South Texas Project Electric Generating Station P.O. Box 289 Wadsworth, Texas 77483

November 30, 2004
NOC-AE-04001819
10CFR50.90

South Texas Project
Units 1 and 2
Docket Nos. STN 50-498, STN-499
Complete Response to Request for Additional Information Regarding a
License Amendment Request for Approval of a Change in Analytical Methodology

**Response to Request for Additional Information
(Non-Proprietary)**

Figure 14-1

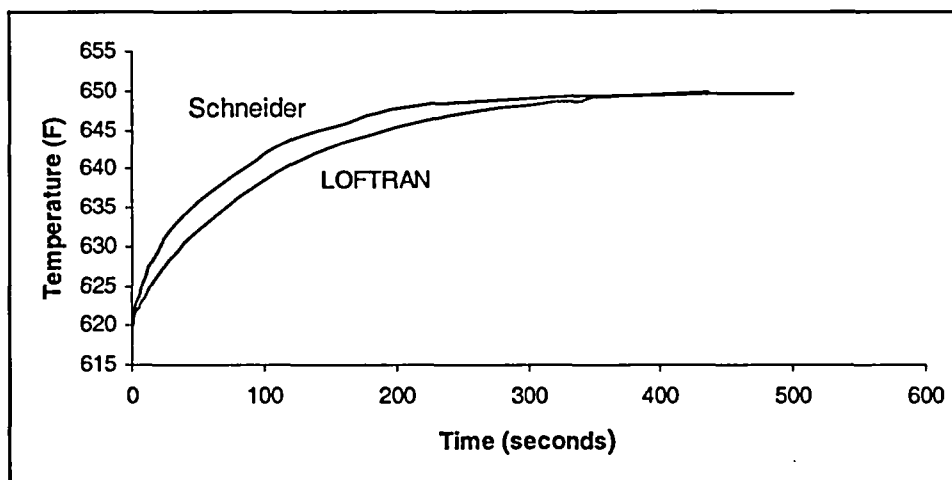
14. WCAP-14882-S1-P, Revision 0 provides the technical basis for the proposed RETRAN thick-metal mass heat transfer model. This topical report does not provide any information regarding verification or validation of the proposed RETRAN thick-metal mass heat transfer model. Please provide a discussion of the work performed to verify that the model performs as expected and that the amount of energy transferred to and absorbed by the RCS metal is accurate and realistic. Include results of any comparisons

made to test data or other benchmarking, and demonstrate that the RETRAN thick-metal mass heat transfer model is not overestimating heat transfer to the RCS metal.

As discussed in the response to RAI #5, Westinghouse performed extensive comparisons of the LOFTRAN thick metal model to the expected response. A comparison of the LOFTRAN thick metal model results for the steam generator inlet metal section to what would be expected based on the data obtained from *Temperature Response Charts*, Dr. P.J. Schneider, 1963 John Wiley & Sons, Inc., was performed for an increase in temperature from 618°F to 650°F. As can be seen in Figure 14-1, the LOFTRAN thick metal model response to an increase in the fluid temperature results in a very similar increase in the metal mass temperature, with the LOFTRAN results being slightly conservative. This conservative response, in addition to the fact that a large portion of the RCS thick metal masses is completely ignored, ensures that the thick metal model is conservative for use in heatup transients.
